**ADDENDUM no. 2 to the
FINAL ENVIRONMENTAL IMPACT REPORT/ENVIRONMENTAL ASSESSMENT for
the
U.S. HIGHWAY 50/EL DORADO HILLS BOULEVARD-LATROBE ROAD
INTERCHANGE PROJECT**

AUGUST 2008

Project Title: U.S. Highway 50/El Dorado Hills Boulevard-Latrobe Road Interchange
EIR/EIS ADDENDUM no.2

FIGURE H

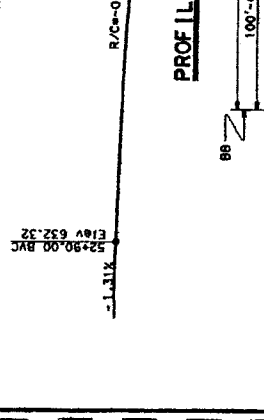
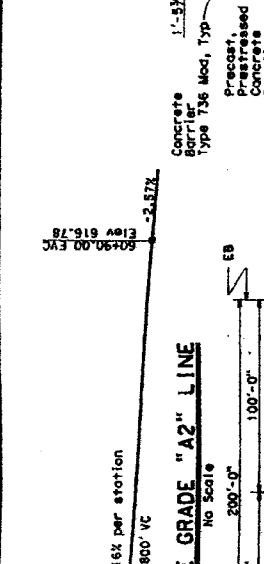
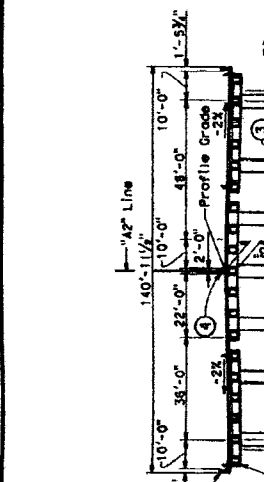
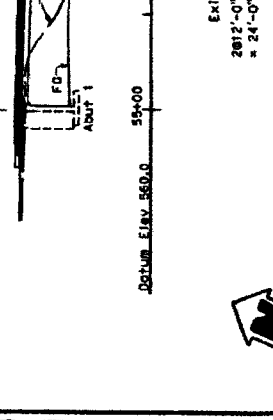
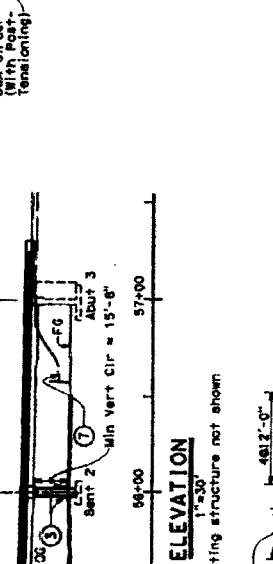
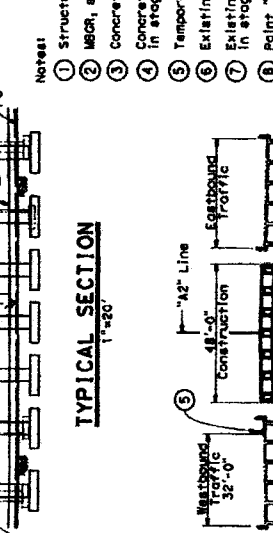
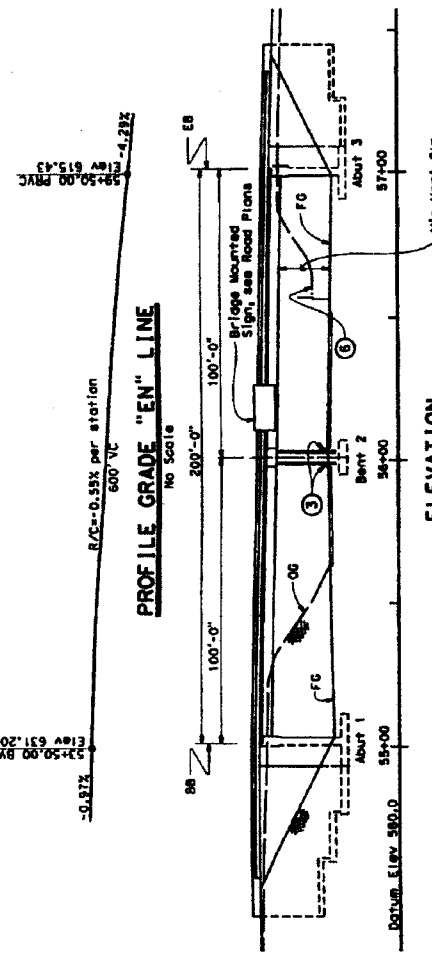
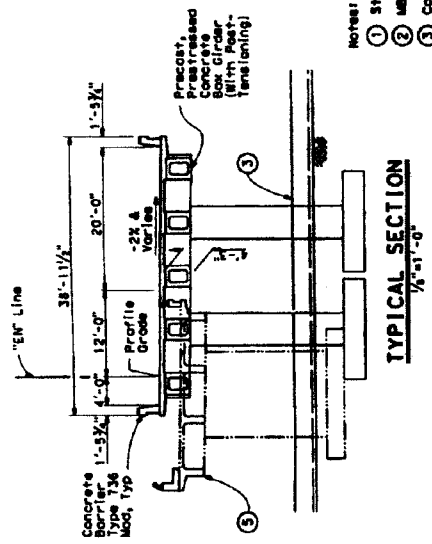
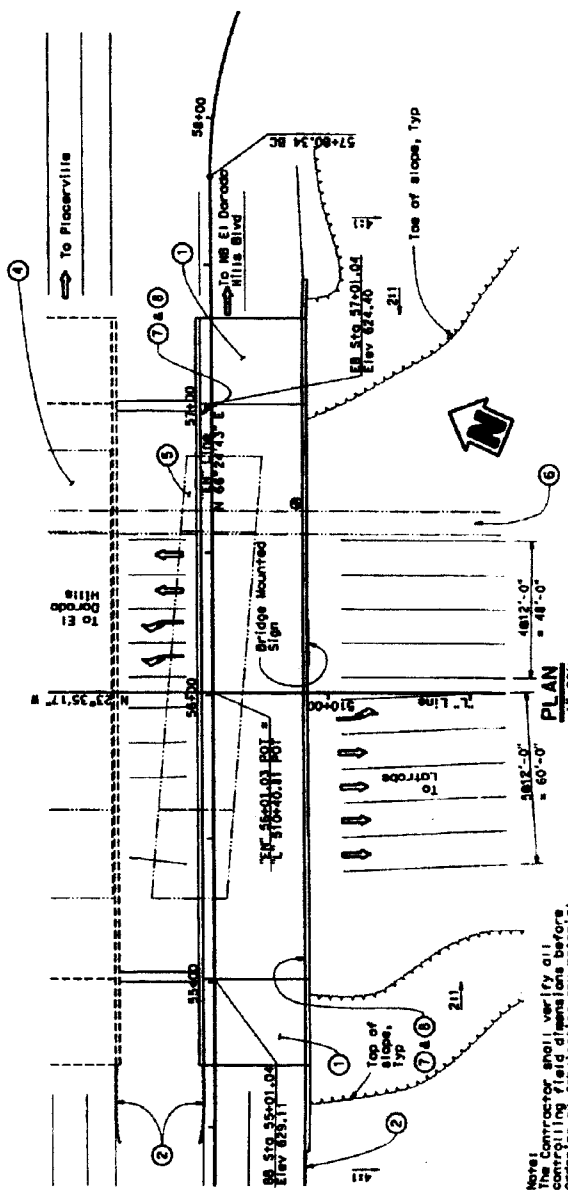
The original type of bridge structure (4 span, cast in place concrete box girders with open end abutment) could not be economically built due to the requirement to maintain a minimum vertical falsework clearance for traffic under the bridge during construction. The proposed replacement bridges are 2 span precast concrete box girders with closed end abutments. The proposed mainline bridge is depicted in Figure H and the EB off-ramp bridge is depicted in Figure I. The bridge length is shorter partially due to hauling limitation for the precast girders. It is also shorter and narrower than the bridge proposed in the EIR/EA because the larger size is not needed and it reduces costs.

The original design dimensions of the mainline bridge in the June 2000 Project Study Report/Project Report (PSR/PR) were 241.5 feet long and 163.67 feet wide. The current proposal would replace the existing mainline bridge with a structure that is 200 feet long and 141 feet wide. The proposed EB off-ramp replacement bridge is shorter for the same reasons but the width (39 feet) remains the same as the bridge in the PSR/PR. The proposed EB off-ramp bridge is 200 feet long vs. 241.5 feet long in the PSR/PR. All replacement bridges are within the same footprint area.

Figure J
LAYOUT
1 of 2
L-3
1" = 50'

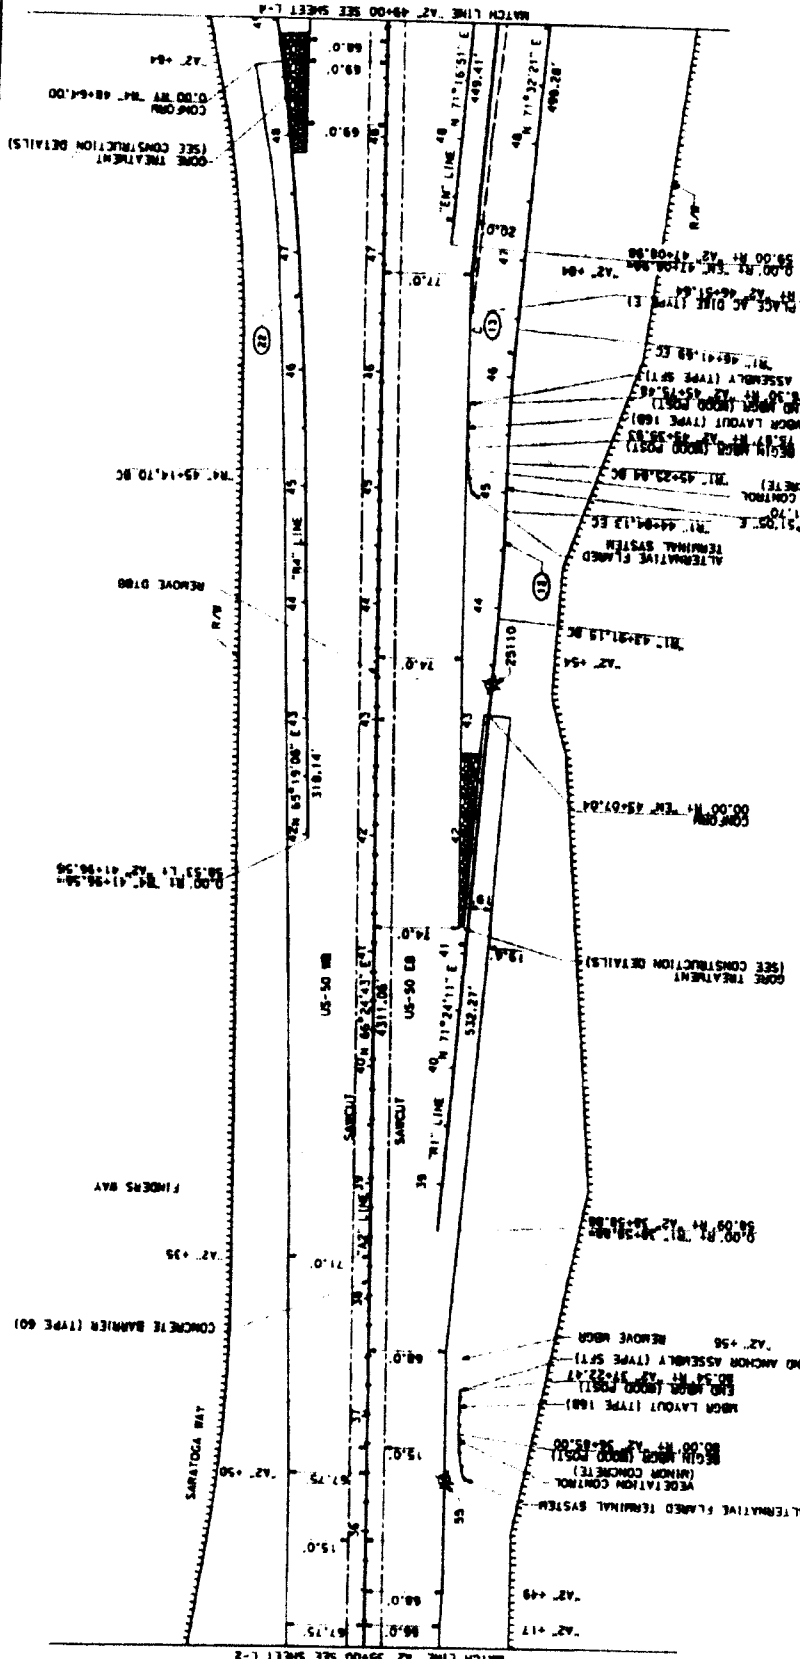
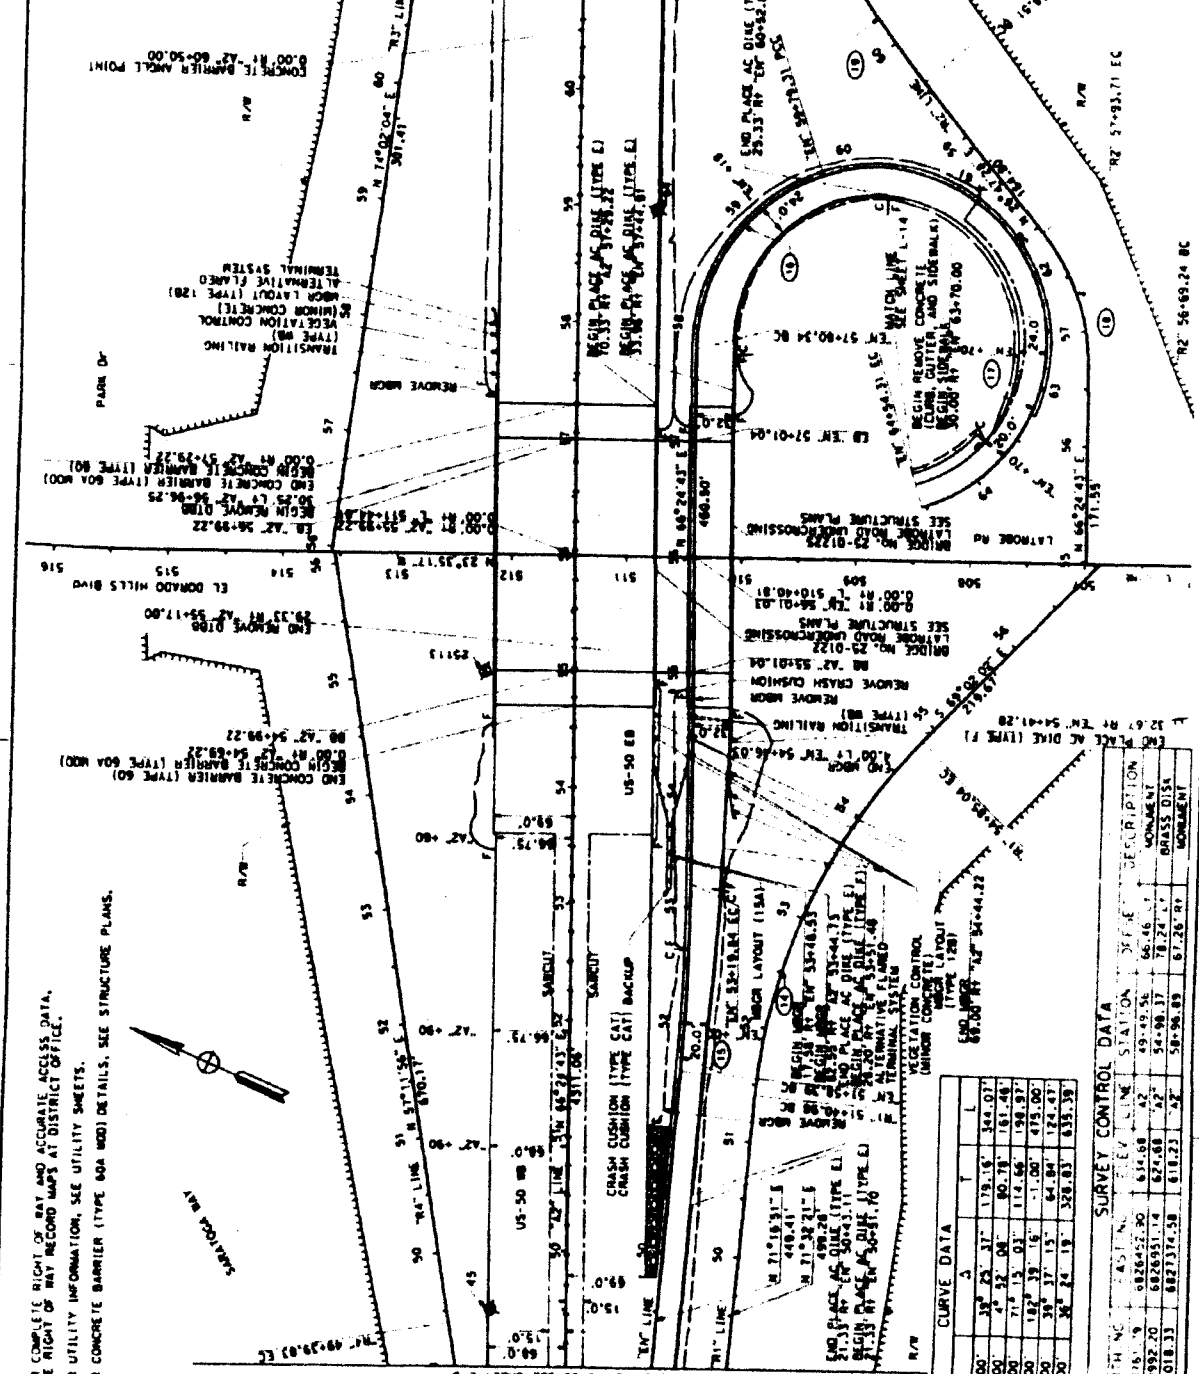
In the proposed project the alignment of the EB off-ramp will be modified from the ultimate configuration in the EIR/EA, shown in Figure B, to an interim condition as shown in Figure J in order to align the ramp with the replacement bridge. This interim phase does not include lengthening and widening (to 2 lanes) the eastbound to southbound off-ramp due to funding limitations. The ramp will remain a single lane instead of 2 lanes and the gore point will occur between the existing and ultimate gore points for the interim condition. This results in a shorter, narrower ramp for the interim condition. The ramp will remain a dedicated ramp for northbound El Dorado Hills Blvd traffic for the interim condition. The ultimate EB ramp alignment will be constructed in Phase 2B per the EIR/EA, as shown in Figure B.
